March 20, 2018
15045

Third Party Review of the Rezoning Petition in Northern Aroostook County, Fish River Chain of Lakes Concept Plan

SLOPE EVALUATION OF FISH RIVER CHAIN OF LAKES DEVELOPMENT AREAS

LOCATION: CROSS LAKE D	FOR: J.D. IRVING LIMITED	INFORMATION: 2011 LIDAR DERIVED DATA PROVIDED BY J.D. IRVING, LIMITED
---------------------------	-----------------------------	--

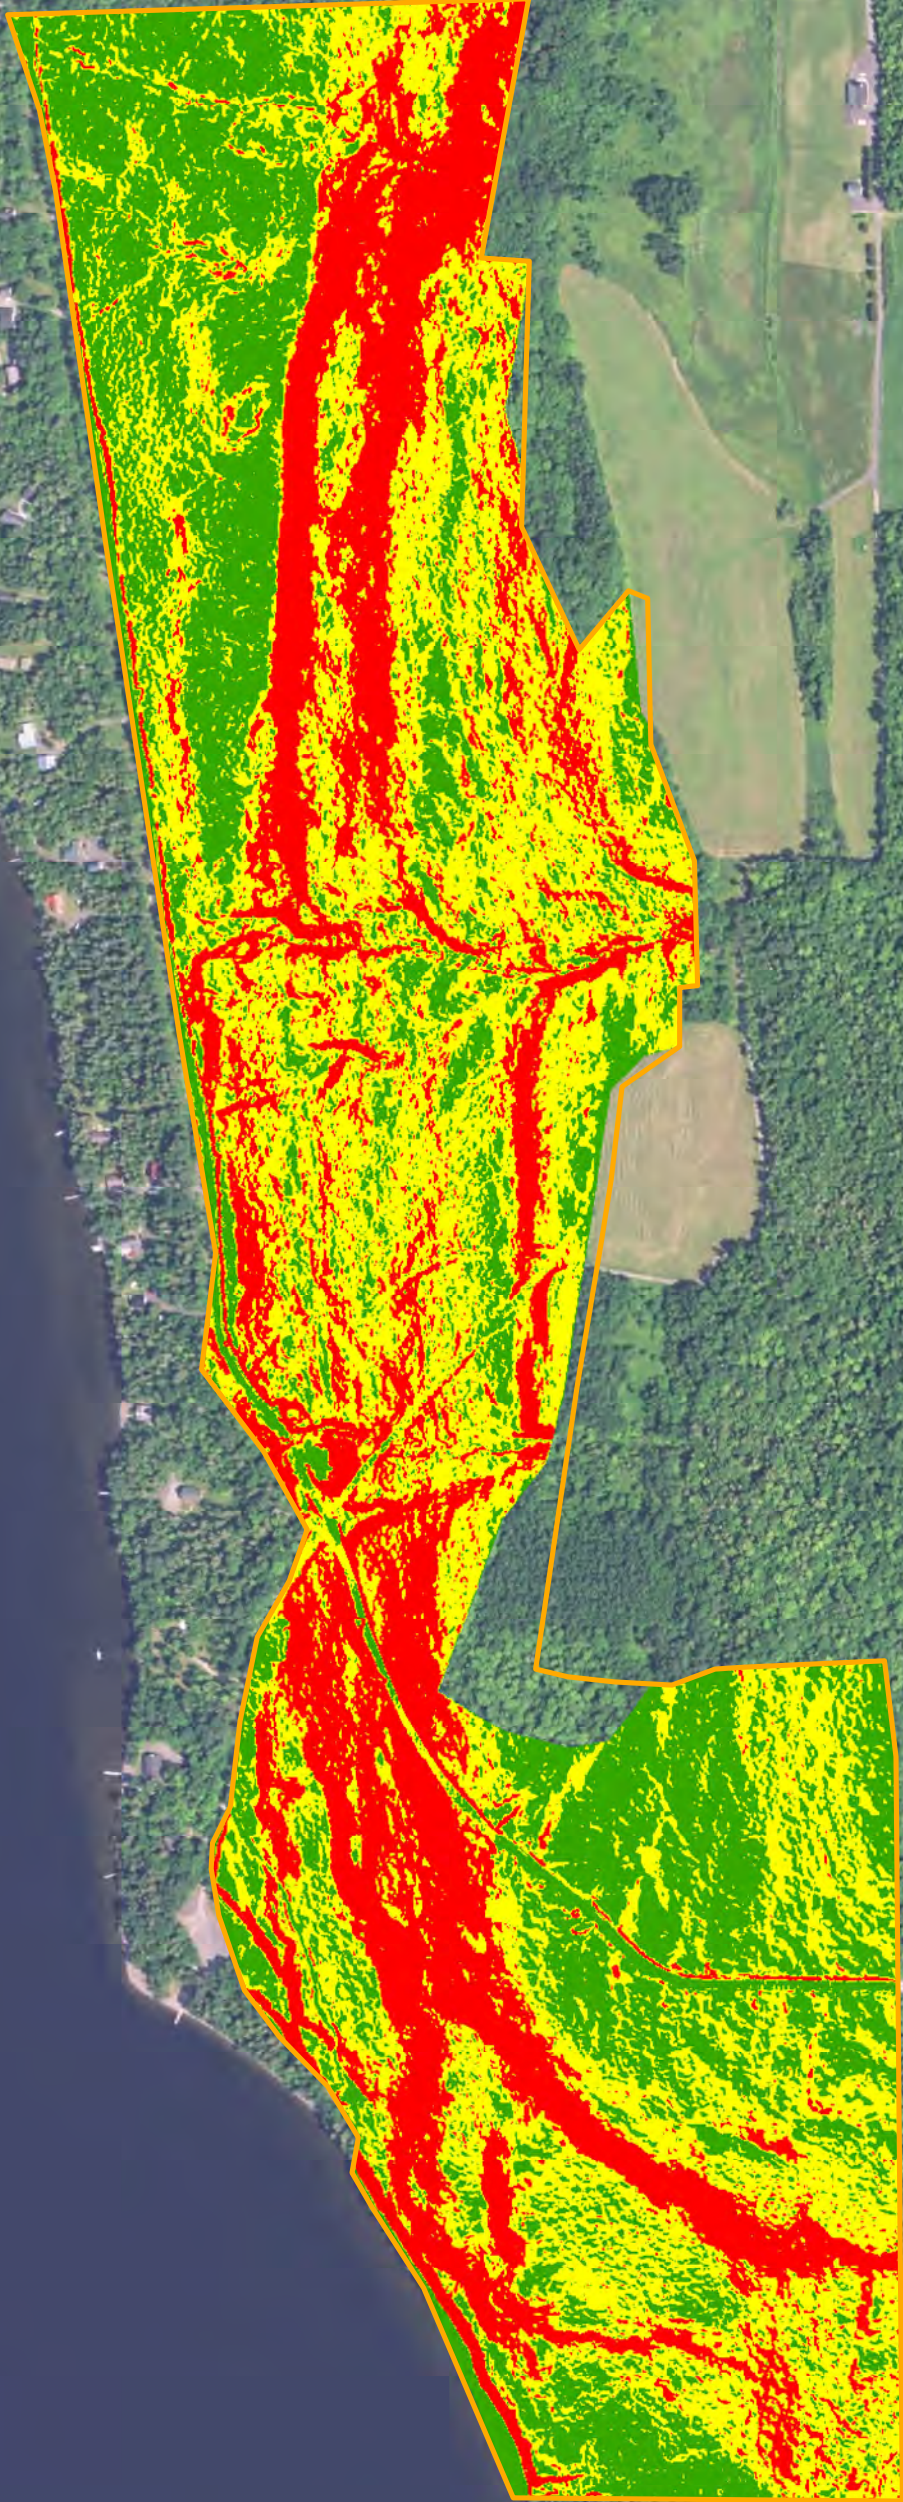
1. Slope Analysis: The slope analysis indicates approximately 49.2 acres of the development area contains slopes greater than 20 percent and are considered unsuitable for development. Slopes 0-10% slopes encompass approximately 54.7 acres. Limited suitability slopes (10 to 20% slopes) encompass approximately 75.8 acres of the project area. The slope assessment suggests the overall parcel is constrained due to slopes with the over 20% slopes consisting of linear features throughout the development area. The slopes of 0-10% are predominately located in the north westerly and south easterly region of the parcel. Given the orientation and locations of the steep and moderately steep slopes, it is expected the development areas will predominantly occur in the identified 0-10% slope area. As a result, the effective development area due to slopes is significantly less than the 185 acres of the overall parcel area. This suggests the relatively low density of 35 units is reasonable for this parcel.

2. The soils in this development area (NRCS Mapping) include PgB/PgC/PgD/PgE (Plaisted gravelly loam), MoB (Monarda-Burnham complex) and HoB/HoC (Howland gravelly loam) soil series. The Pg soils generally gravelly loams and located on slopes 3% to 60% (B-E slope designation). These soils are generally well drained with a water table over 26 inches and considered a hydrologic group "C" soils. These soil types do not suggest any significant limitations for development beyond localized limitations as a result of a higher-grade soil mapping and steep slopes. The MoB soils are silt-loams, poorly drained and generally have a water table of 0 to 12." The MoB soils are considered not suitable for development due to the depth to groundwater, potential presence of wetlands and erosion potential. The HoB and HoC soils are generally gravelly loams and located on slopes 3% to 8% and 8% to 15% respectively. These soils are generally moderately well drained to well drained with a water table over 16 inches and considered a hydrologic group "C/D" soils.

Considering the soil types and associated development limitations including slopes over 20%, our assessment suggests that the project area and number of planned units (35) yields an effective net density of 1.9 acres/unit. This represents a reasonable and appropriate net development density (*Please refer to the development matrix analysis appended to this report*) recognizing that significant areas of the 187 acres will be constrained and not suitable for development. This suggests the development units will most likely be located in the north westerly and south easterly portions of the site. This assessment includes deductions for slopes over 20% and allowing for 25% of the 10% to 20% (limited suitability slopes) to be considered not suitable.

LOCATION: CROSS LAKE E	FOR: J.D. IRVING LIMITED	INFORMATION: 2011 LIDAR DERIVED DATA PROVIDED BY J.D. IRVING, LIMITED	SCALE: 1" = 400'
			DATE: 03/08/18

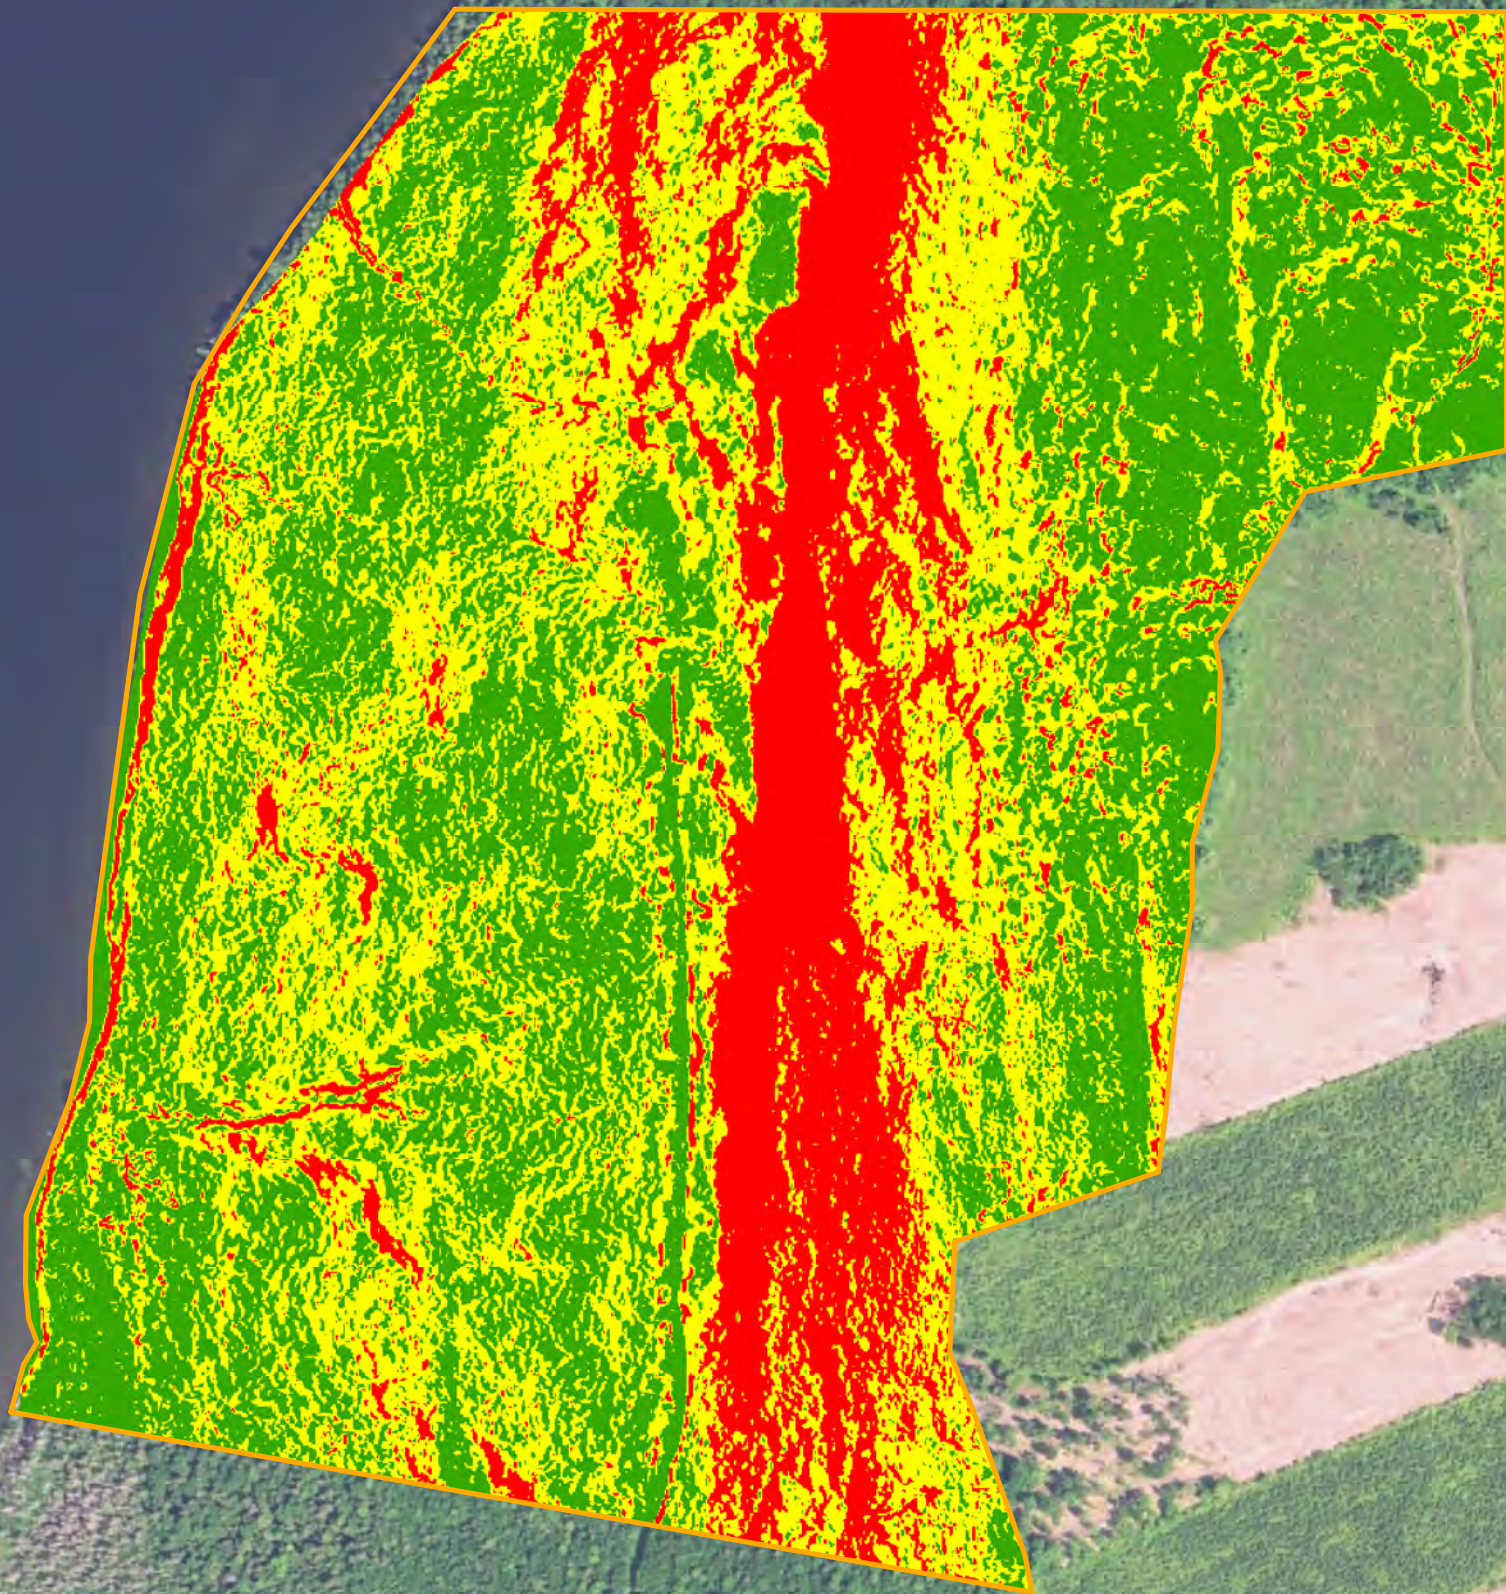
1. Slope Analysis: The slope analysis indicates approximately 32.4 acres of the development area contains slopes greater than 20 percent and are considered unsuitable for development. Slopes of 0-10% encompass approximately 66.4 acres. Limited suitability slopes (10 to 20% slopes) encompass approximately 64.3 acres of the project area. The slope assessment suggests the over 20 percent slopes are primarily located in north-south orientation running parallel to the lake just easterly of the center of the parcel. As a result, development areas are expected to either side of this steep slope feature. The slopes of 0-10% and 10-20% comprise the majority of the parcel and represent slope areas suitable for the intended unit density.

2. The soils in this development area (NRCS Mapping) include PgB/PgD (Plaisted gravelly loam), MoB (Monarda-Burnham complex) and HvB/HvC (Howland loam) soil series. The Pg soils generally gravelly loams and located on slopes 3% to 8% and 15% to 30% (B and D slope designation). These soils are generally well drained with a water table over 26 inches and considered a hydrologic group "C" soils. These soil types do not suggest any significant limitations for development beyond the steep slope areas and localized limitations as a result of a higher-grade soil mapping.

The MoB soils are silt-loams, poorly drained and generally have a water table of 0 to 12.” The MoB soils are considered not suitable for development due to the depth to groundwater, potential presence of wetlands, erosion potential and development limitations. The HvB and HvC soils are generally very stony loams and located on slopes 3% to 8% and 8% to 15% respectively. These soils are generally moderately well drained to well drained with a water table of 17 to 26 inches and considered a hydrologic group “C/D” soils.

Considering the soil types and associated development limitations including slopes over 20%, our assessment suggests that the project area and number of planned units (60) yields an effective net density of 1.4 acres/unit. This represents a reasonable and appropriate net development density (Please refer to the development matrix analysis appended to this report). This assessment includes deductions for slopes over 20% and allowing for 25% of the 10% to 20% (limited suitability slopes) to be considered not suitable.

LOCATION: LONG LAKE A	FOR: J.D. IRVING LIMITED	INFORMATION: 2011 LIDAR DERIVED DATA PROVIDED BY J.D. IRVING, LIMITED	SCALE: 1" = 400'
			DATE: 03/07/18

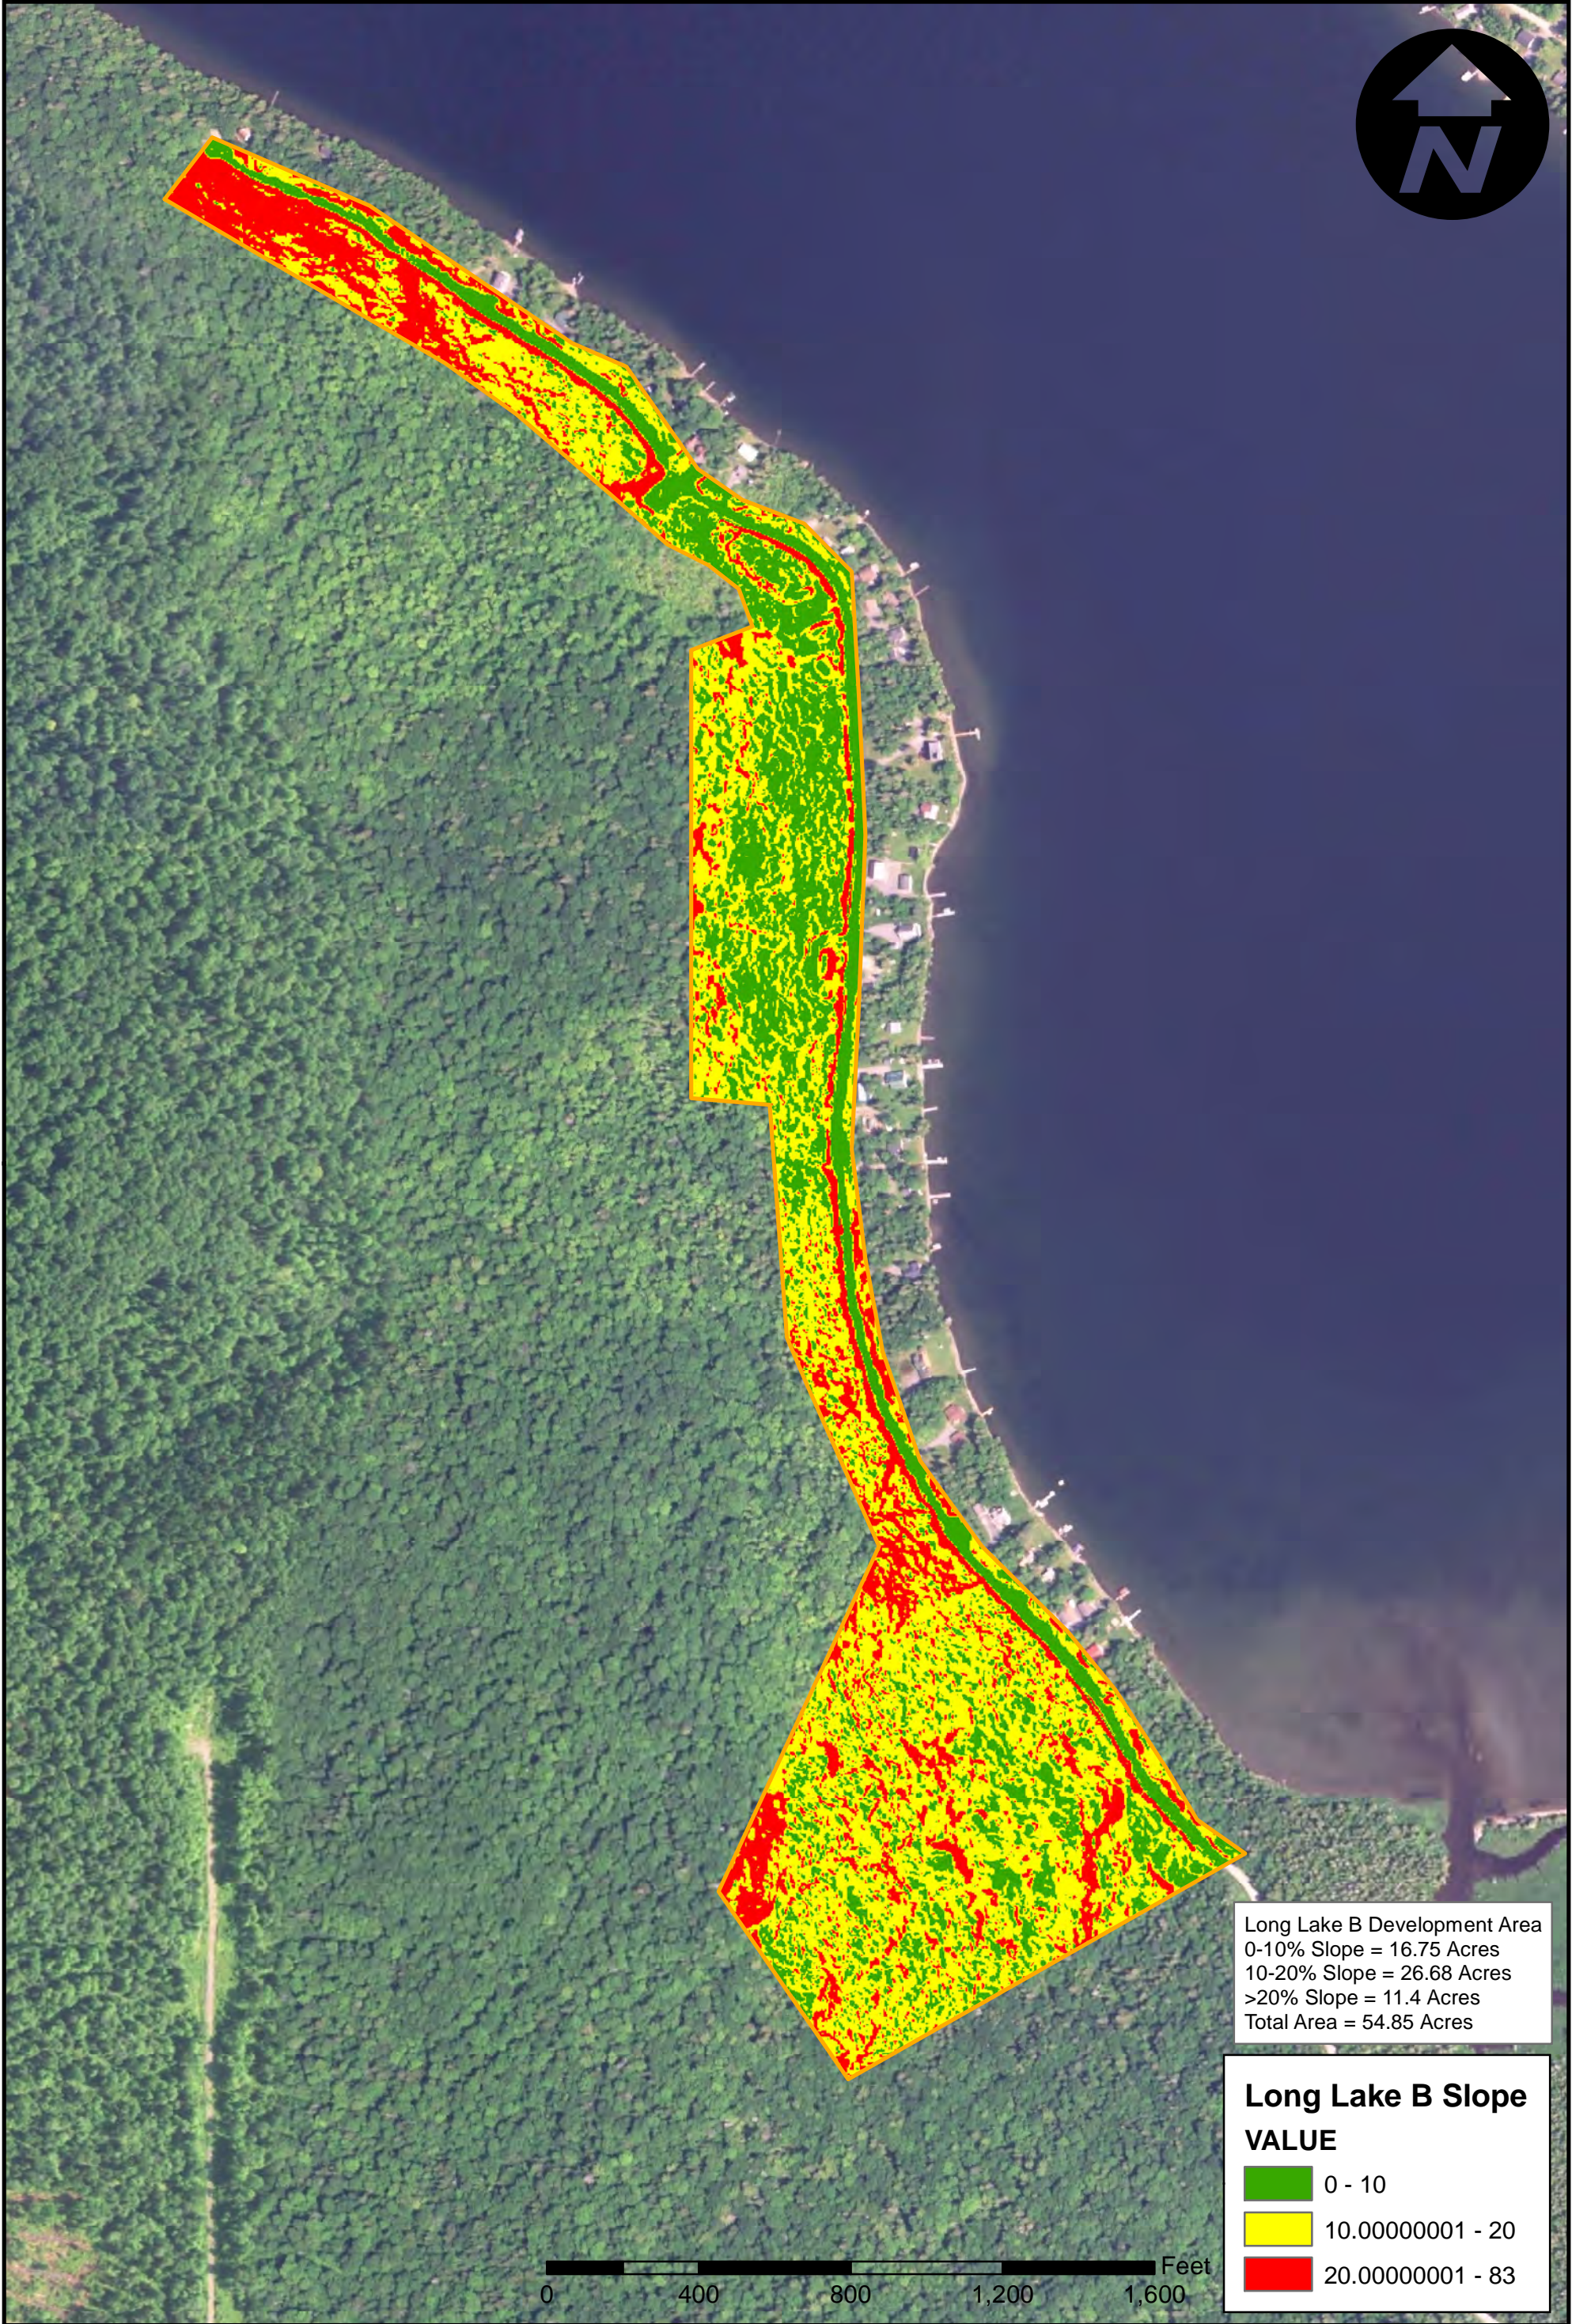
1. Slope Analysis: The slope analysis indicates approximately 24 acres of the development area contain slopes greater than 20 percent and are considered unsuitable for development. The greater than 20% slopes are generally associated with linear slope features. Slopes 0-10% slopes encompass approximately 31 acres. Limited suitability slopes (10 to 20% slopes) encompassing approximately 73 acres of the project area. The slope assessments suggest the development area is partially suitable for the intended purposes noting that the slopes greater than 20% are not considered suitable for development due to limitations for wastewater disposal systems, erosion and drainage control considerations and slope stability. Provided the development planning avoids the steeper slopes and recognizes the partial limitation of the 10% -20% slopes, adequate land area exists to accommodate the 50-unit density.

2. The soils in this development area (NRCS Mapping) include PvC (Plasited Howland association) and HcV (Howland silt-loam) soil series. These soils range from a gravelly loam to a silt-loam and are moderately well drained with a water table over 16 inches and considered a hydrologic group "C/D" soils. These soil types do not suggest appreciable limitations for development beyond localized limitations as a result of steep slopes (over 20%) and results of higher-grade soil mapping. We would note that the HcV

soils are considered a finer soil and may be more susceptible to erosion when disturbed but are generally suitable for development.

Considering the soils, streams, wetlands and associated development limitations, slopes over 20%, our assessment suggests that the project area and number of planned units (50) yields an effective net density of 1.5 acres/unit. This represents a reasonable and appropriate net development density (Please refer to the development matrix analysis appended to this report). This assessment includes deductions for slopes over 20% and allowing for 25% of the 10% to 20% (limited suitability slopes) to be considered not suitable.
